## Burlington Development Review Board

# Development Review Board

**Tuesday, February 17, 2026, 5:00 PM**

**ZP-26-18; 125 Lakeside Avenue (E-LM, Ward 5) Ride Your Bike, LLC / Andrew Foley**  
**Proposed construction of a mixed-use residential and commercial development with related site infrastructure improvements. (Project Manager, Scott Gustin)**

**Figure 1: Comparison of Champlain Parkway Volumes to 11/25 Traffic Counts along Lakeside Avenue**

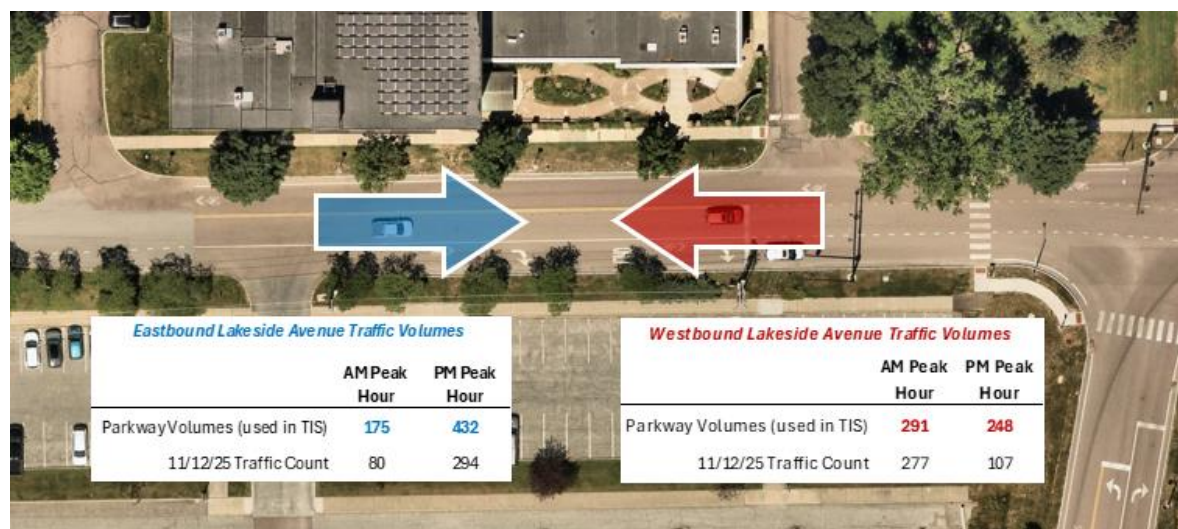
- Given the changes proposed to the existing conditions at 125 Lakeside Avenue, the Innovation Drive access onto Lakeside Avenue was not analyzed as part of the No Build conditions. See response below for further detail on assumptions and methodology employed under Build conditions.

- Clarify how any relocated parking spaces for HULA are reflected in traffic counts, trip generation, or operational assumptions
  - As noted above, the base traffic volumes used in the Traffic Impact Study are based on the ETC+20 volumes in the *Champlain Parkway FSEIS* Build Alternative 2, plus estimated background trips generated by Cambrian Rise and City Place. As shown in **Figure 1** below, the Parkway volumes along Lakeside Avenue used in the Traffic Impact Study are higher than traffic count data collected in November 2025 during both peak hours, indicating the volumes used for the Traffic Impact Study are conservatively higher than actual current traffic volumes.

- Any shift in current Hula employee parking from the 125 Lakeside Avenue lot west to the Hula Lakeside site would still generate the same traffic volumes along Lakeside Avenue east of Innovation Drive.

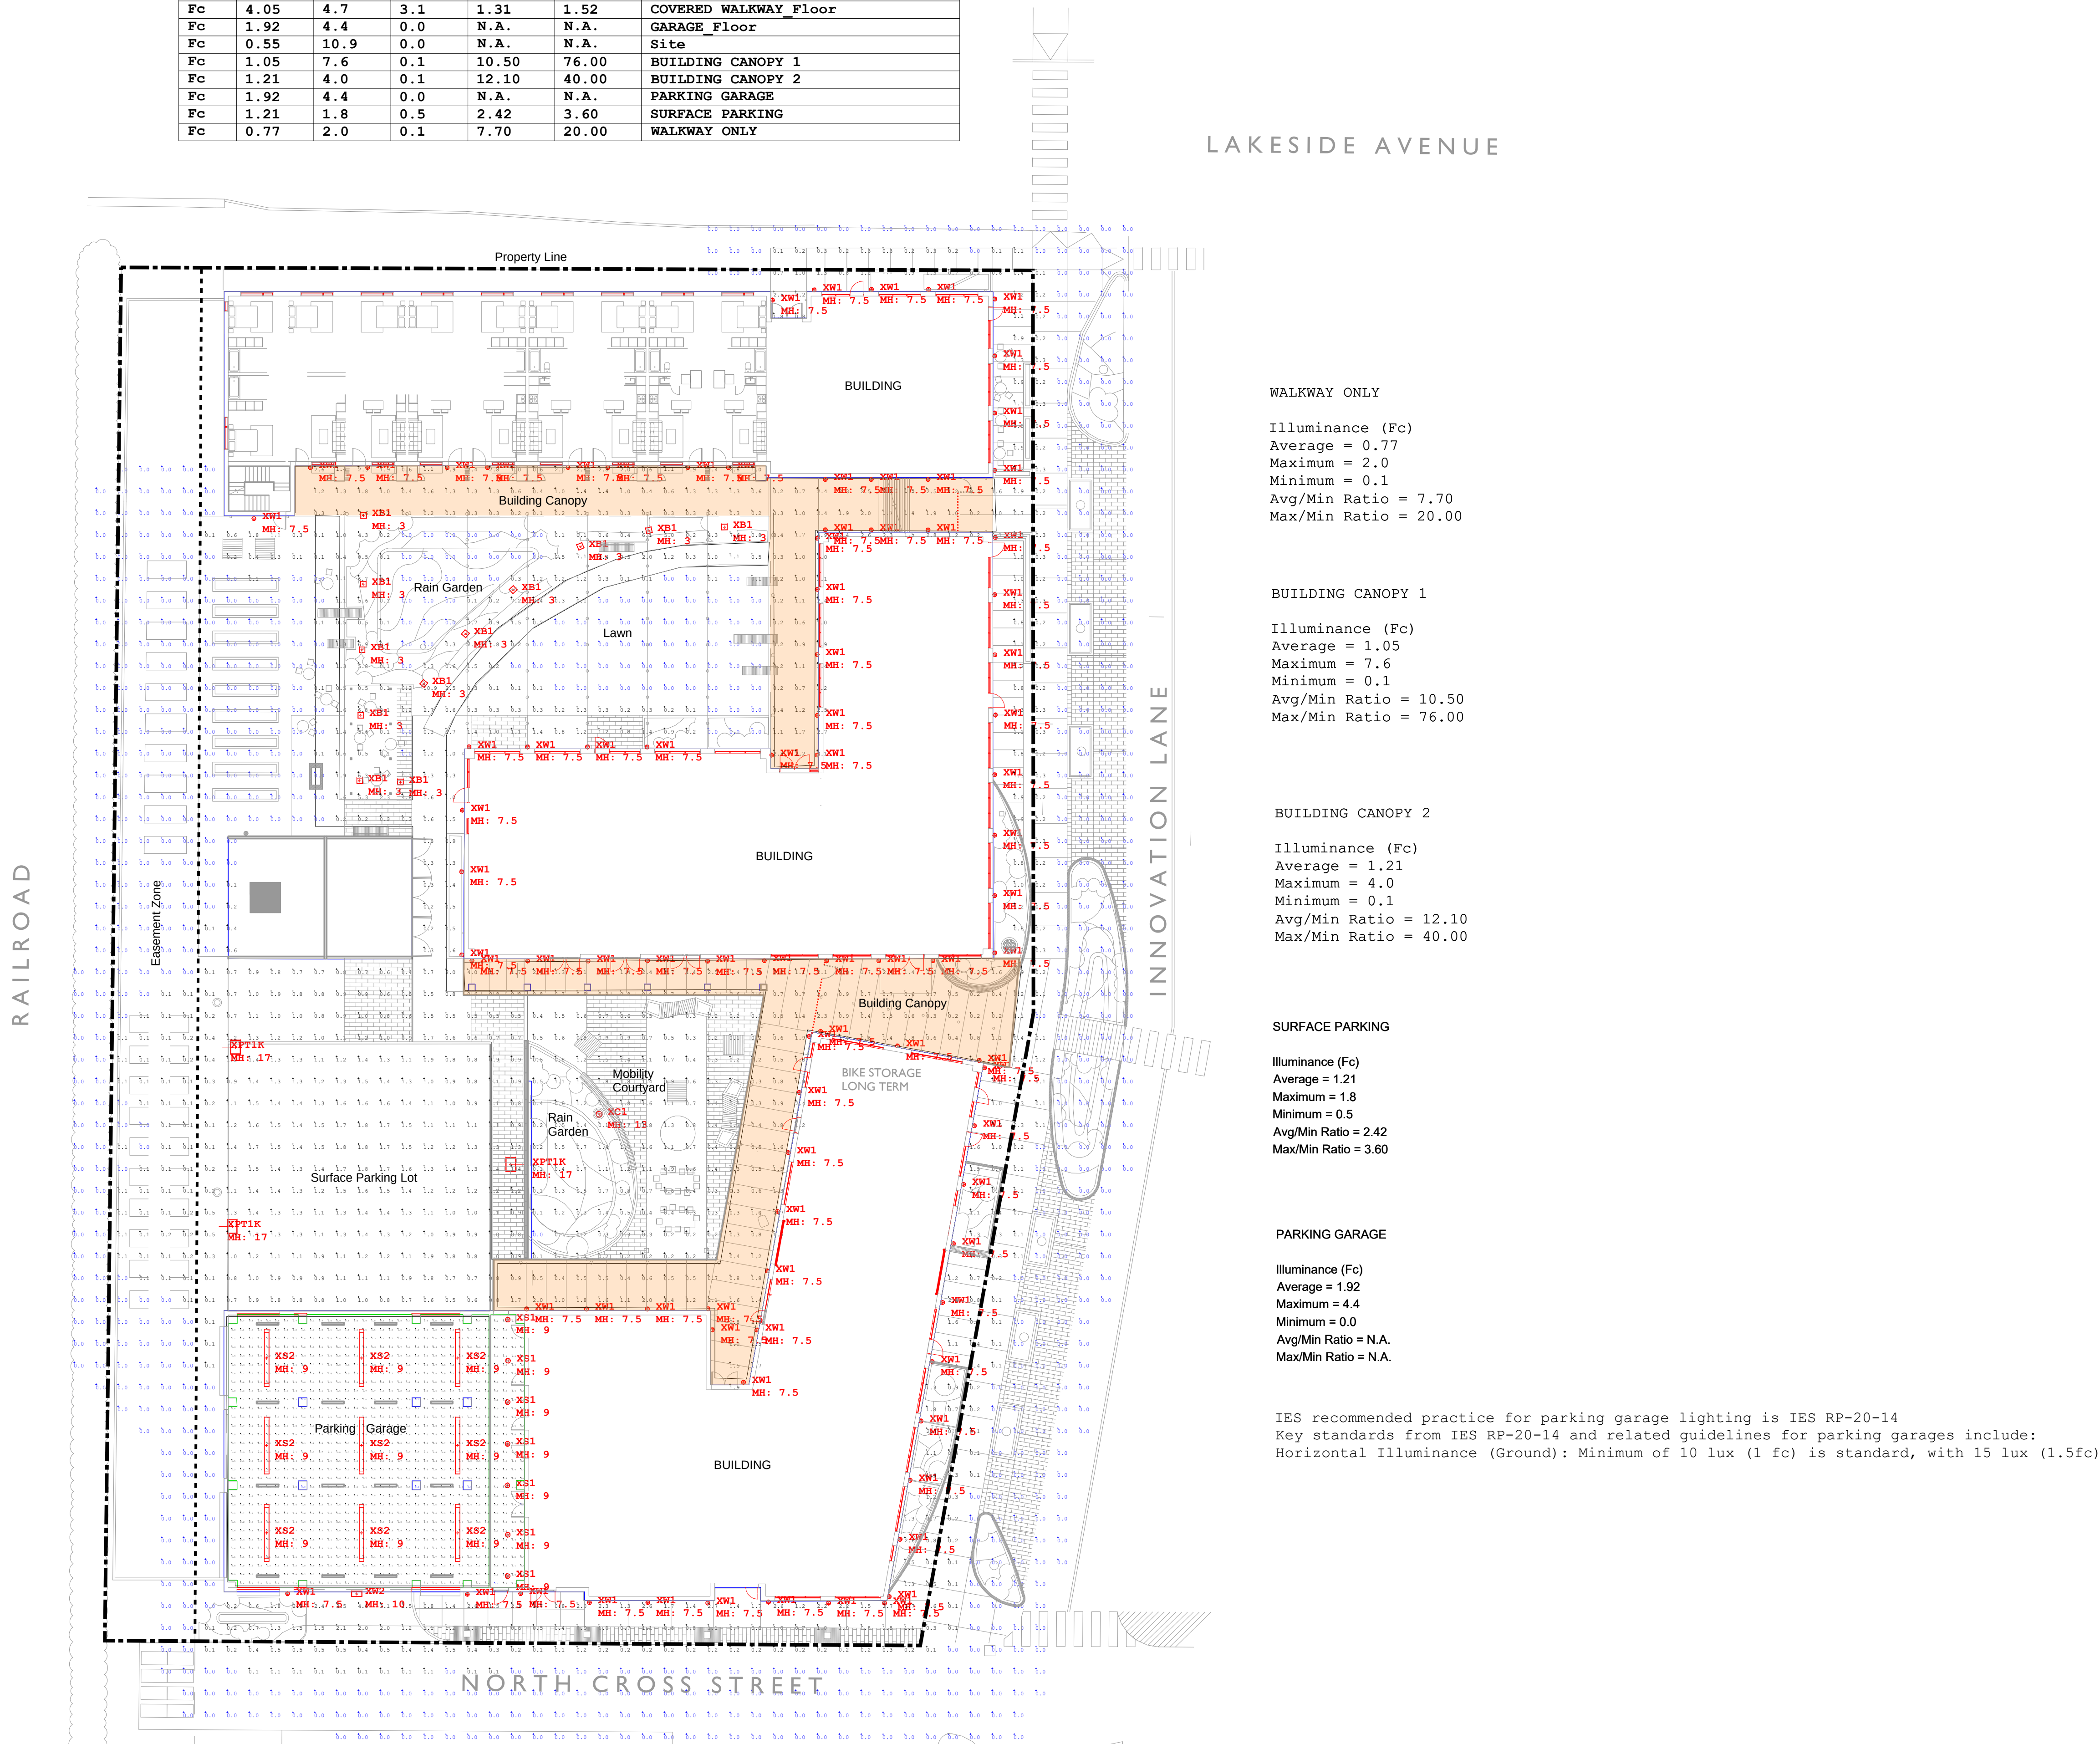
- Confirm whether total peak-hour trips (approximately 80–90 vehicles) are consistent with the assumed land uses and internal capture methodology.
  - Based on previous experience and engineering judgement we feel that the trip generation estimates for the Phase A building is reasonable and consistent with the assumed land uses and internal capture methodology.

- Clarify how localized LOS D or E conditions and associated queue lengths were evaluated with respect to spillback potential.
  - Aside from the Innovation Center approach to Lakeside Avenue (which remains a LOS E in both the 2033 No Build and Build conditions), the LOS E conditions presented in the Traffic Impact Study are limited to the Flynn Avenue/Champlain Parkway intersection – results that are consistent with the operational results previously reported in the Champlain Parkway FSEIS, the South End City Market Traffic Impact Study, and the South End Multimodal Center Study.

- See above regarding the internal capture methodology employed. The trip generation and internal capture estimates were made on a vehicle trip basis.
- Include applicable ITE rates or calculations behind trip numbers shown in Figure 4.
  - See expanded trip generation table below.
